ITEM NO.	PART NO.	DESCRIPTION OR SIZE	QTY. REQ.
PARTS LIST			
UNLESS OTHERWISE SPECIFIED	ORIGINATOR	R. SCHMITT	5-00
-.XX	DRAWN	REEDER	5-00
± .02	CHECKED	C.NILLA	6-00
± .005	APPROVED	R. SCHMITT	6-00
USED ON MC-397173 ITEM 1			
MATERIAL 3/4 X 9.50 X 13.00 ALLOY #280 MUNTZ METAL CENTRAL STEEL & WIRE			
 FERMI NATIONAL ACCELERATOR LABORATORY UNITED STATES DEPARTMENT OF ENERGY			
PPD/MECHANICAL SUPPORT CDMS BREAKOUT BOX CONNECTOR HOLDER "B"			
SCALE	DRAWING NUMBER	SHEET NO.	REV.
1/2	9213.300-MC-397170	1 OF 1	D

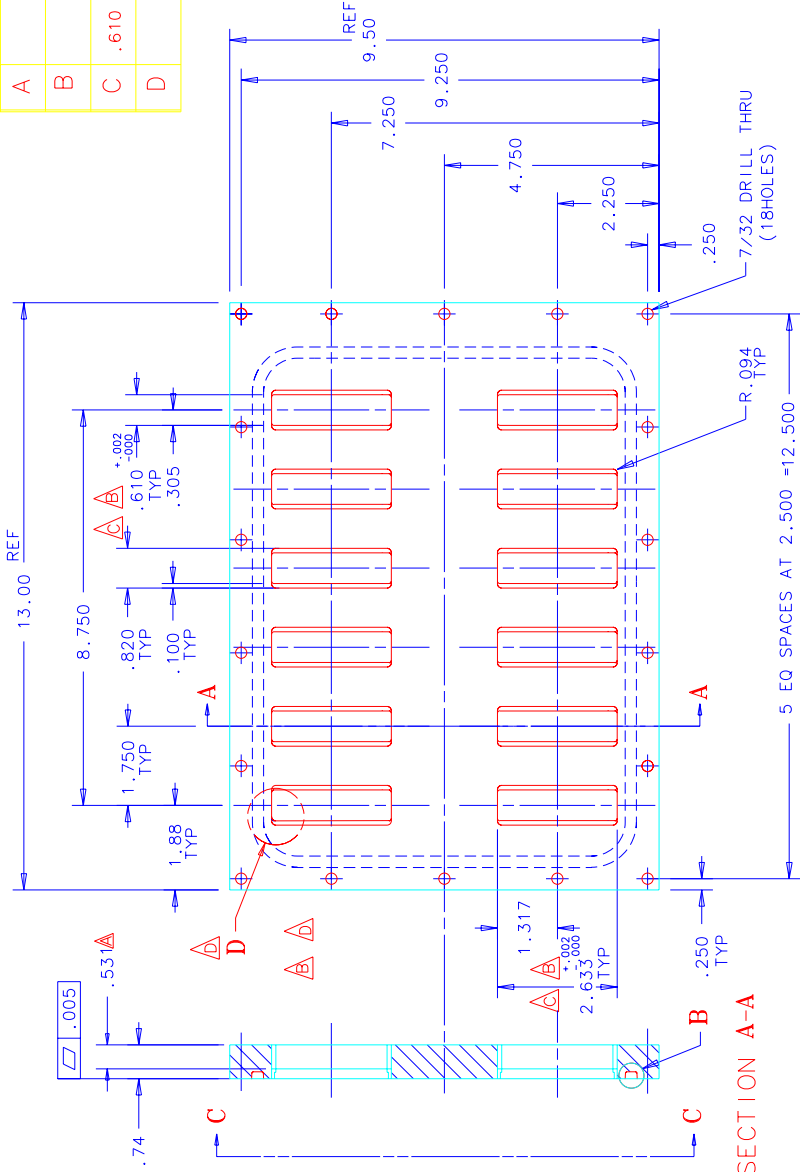
REV.	DESCRIPTION	DRAWN	DATE
A	.531 WAS .125	REEDER	8/28/00
B	2.250 WAS 2.000 2.634 WAS 2.650 .611 WAS .620	C.NILLA	8/28/00
C	.611 X 2.633 WAS .611 X 2.634 .062 R WAS .053 R VIEW D ADDED 2.250 DIM REMOVED	REEDER	11-20-00
D		C.NILLA	11-27-00
		REEDER	12-15-00
